Global Change Notification (GCN)

GCN Number

Series

Before and after the rib change

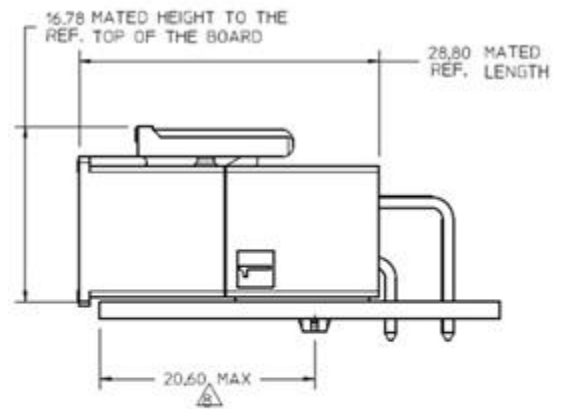
Change Description

⚠ TO AVOID INTERFERENCE BETWEEN RECEPTACLE AND PCB, HEADER MUST BE PLACED WITHIN 20,6 MAX FROM EDGE OF PCB AS SHOWN FOR 4 THRU 12 CKTS, FOR 2CKT PARTS THIS DIMENSION IS 15,1 MAX.
